SUBJECT: Application for amend to license DPR-23, adopting provisions of 10CFR50, App J, Option B which will be implemented per RG 1.163, "Performance-Based Containment Leak-Test Program," dtd Sept 1995.

H. B. ROBINSON STEAM ELECTRIC PLANT, UNIT NO. 2
DOCKET NO. 50-261/LICENSE NO. DPR-23
REQUEST FOR TECHNICAL SPECIFICATIONS CHANGE
PERFORMANCE-BASED CONTAINMENT INTEGRATED LEAK RATE TESTING

BASIS FOR CHANGE REQUEST

Figure 1

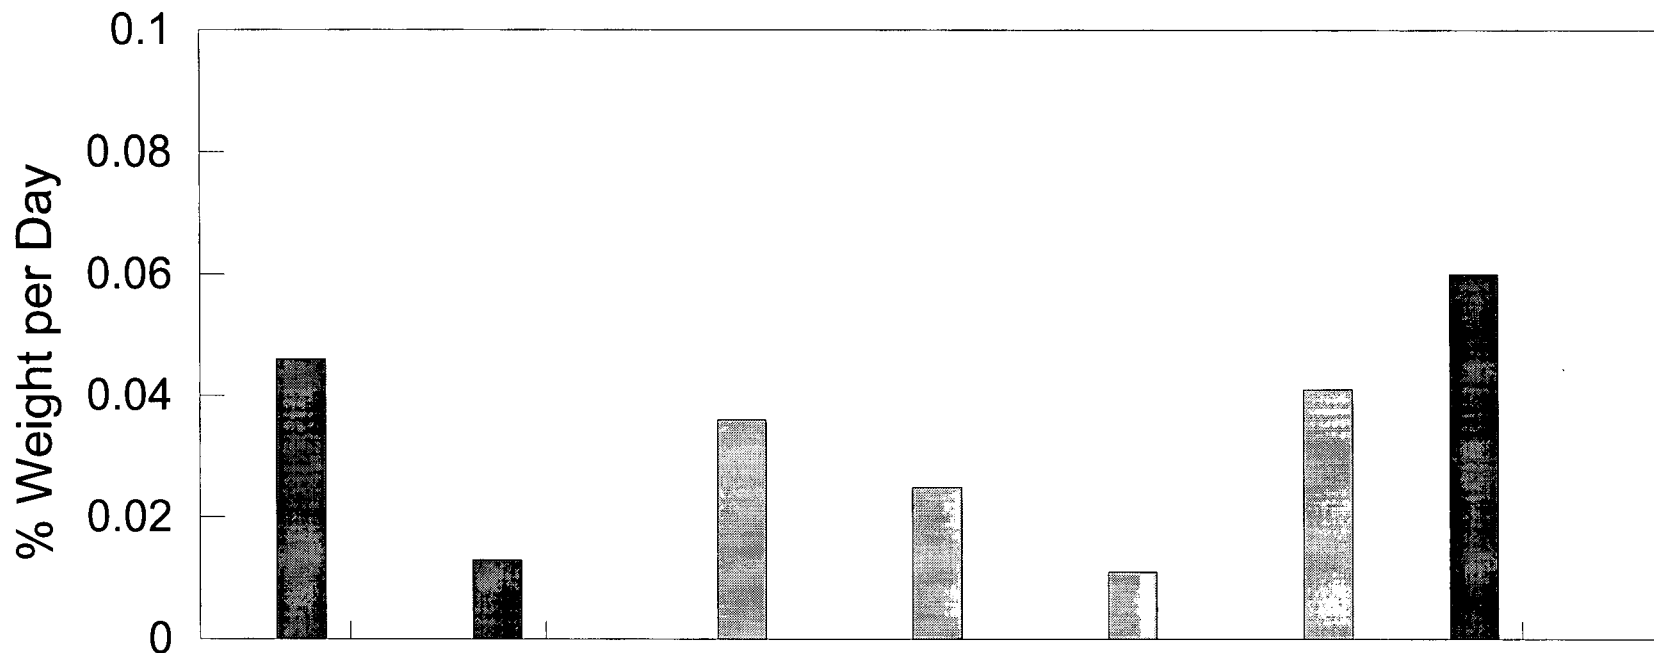
Our testing history indicates that during all Type A testing, the 10 CFR 50, Appendix J and TS leak rate acceptance criteria have not been exceeded (i.e., see the enclosed Figure 1, "Historical ILRT Results"). There are no existing anomalies specific to the functional requirements of the containment structure itself which would adversely impact extending the Type A test frequency schedule in accordance with 10 CFR 50, Appendix J, Option B. The 1992 SIT results indicated good agreement with the 1970 and 1974 SIT results and all acceptance criteria were satisfied, ensuring the continued integrity of the structure.
